Office Action Summary

10/598,782

DETAILED ACTION

Fig. 2

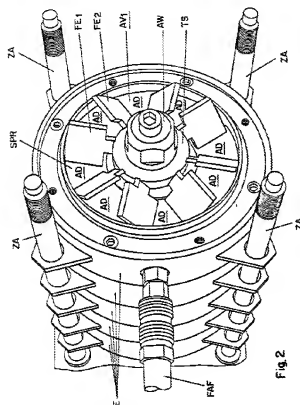
Hug teaches plural sets of blades attached on shaft AW, with a filter tray located between each two sets of blades – see the figures copied above.

There is no requirement that the blades of each set of blades must be oriented in any specific direction/location with respect to its adjacent sets of blades. Thus the blades can be relatively overlapping and/or offset. Claim 1 requires only one filter tray and one rotor. One could have several of this arrangement of rotor and filter trays in a barrel as contemplated by the broadest reasonable interpretation of claim 1.

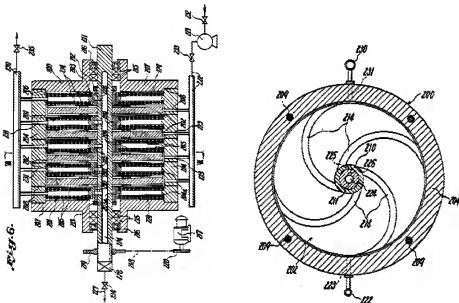
Sasaki teaches filter discs alternately interspersed with rotor discs as claimed – see figures 6 and 7 copied below. The rotor discs have vanes, ribs or ridges (214) on it.
